SUBJECT: ERRATA FOR FINAL SIGNIFICANCE DETERMINATION FOR A WHITE

FINDING AND NOTICE OF VIOLATION, NRC INSPECTION REPORT 05000298/2008008, COOPER NUCLEAR STATION

SUBJECT: FINAL SIGNIFICANCE DETERMINATION FOR A WHITE FINDING AND

NOTICE OF VIOLATION, NRC INSPECTION REPORT 05000298/2008008.

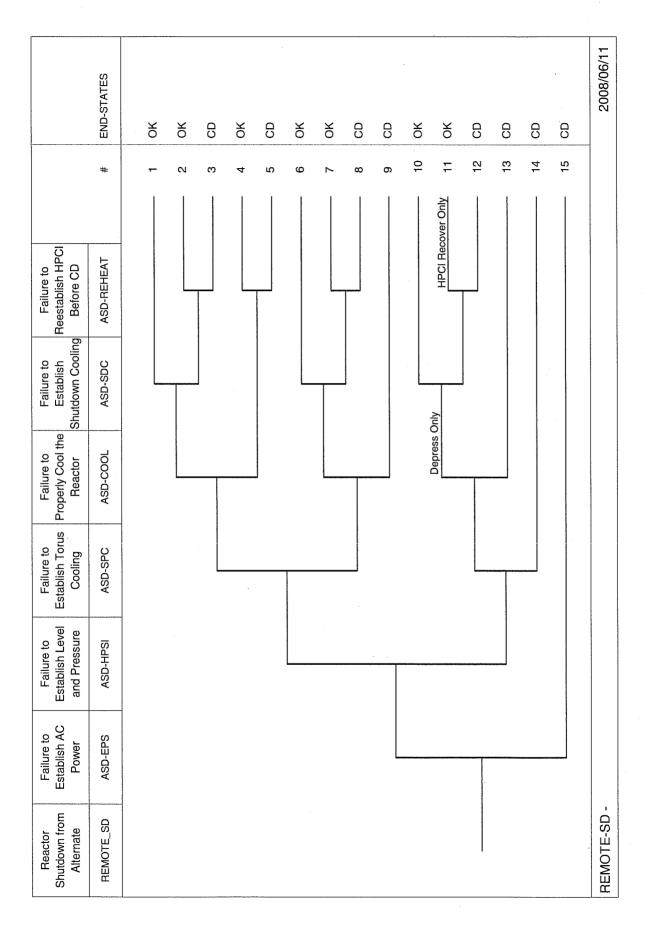
As documented in Assumption 5, the analyst calculated a combined non-recovery probability using the event tree shown in Figure 2 in the Attachment.

Table 4 documents the final split fractions used in quantifying this event tree.

Using the event tree in Figure 2 and the split fractions in Table 4, the analyst calculated a combined non-recovery probability of 7.9 x 10⁻². The licensee's combined non-recovery probability was 4.0 x 10⁻³. The licensee used a similar approach to quantify this value. However, the licensee assumed that operators would always shut the safety-relief valves upon determining that reactor pressure vessel water level was decreasing. The analyst assumed that some percentage of operators would continue to follow the procedure and attempt to recover from the failed RHR valve or try alternate methods of low-pressure injection. In addition, the analyst identified the following issues that impacted the licensee's analysis:
